BCA ASSESSMENT REPORT

**PROJECT: TNT TRANSPORT TERMINAL
ADDRESS: LENORE LANE, ERSKINE PARK**

Revision 1

Date: 27 August 2013

Figure 1 – Rise in Storeys of Warehouse Building – C1.2(c) issue.

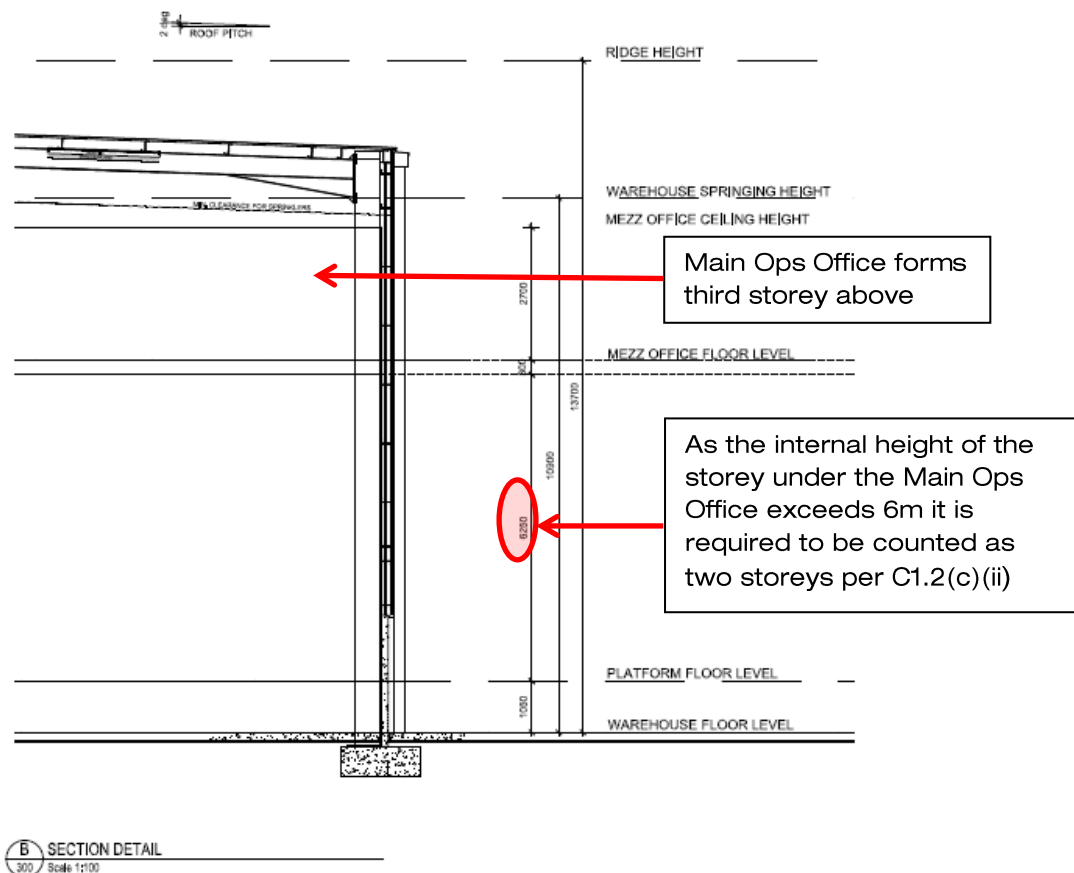
Comments: Main Office: Rise of 2 Storeys – the rooftop carpark is open to the sky and as such is not defined as a storey per C1.2. Warehouse: The area below the Main OPS Office measured from the platform level to the underside of the office slab exceeds 6m (6.25m per drawing no. 300/A. In accordance with C1.2(c) this area is deemed to be counted as two storeys, hence the overall rise in storeys of the warehouse building is three – see diagram below. The implication of this rise in storeys to the Warehouse Building is the need for Type B Construction to be applied – see notes under Spec. C1.1 below in relation to Type B Construction fire rating requirements applicable to the warehouse building.

Figure 2 – Conveyor System – West – Assumed Egress paths

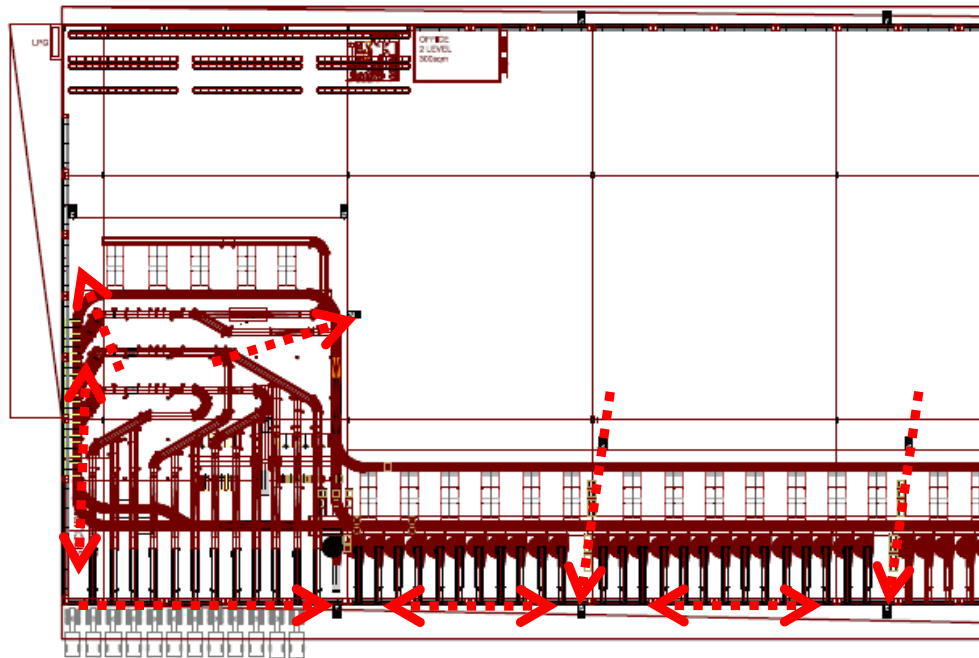
Comments: The exit travel distances in the buildings are considered to be non-compliant with the requirements of Clause D1.4 in the following areas:

- Central Area of the Warehouse Building – maximum exit travel distance of 70m-75m.
- Rooftop Level of Main Office/Carpark Building - maximum exit travel distance of 50m

Note: The above egress distances take into consideration the indicative conveyor/automatic sorting system layout and assumed egress paths through/under/over the conveyors (as they are not detailed on the plans – see notes below) – a more detailed egress assessment will be required prior to the lodgement of the CC Application and commencement of the Fire Engineering process.

The above non-compliance issues are required to be addressed as an alternative solution by the Fire Safety Engineer to demonstrate compliance with Performance Requirements DP4 & EP2.2.
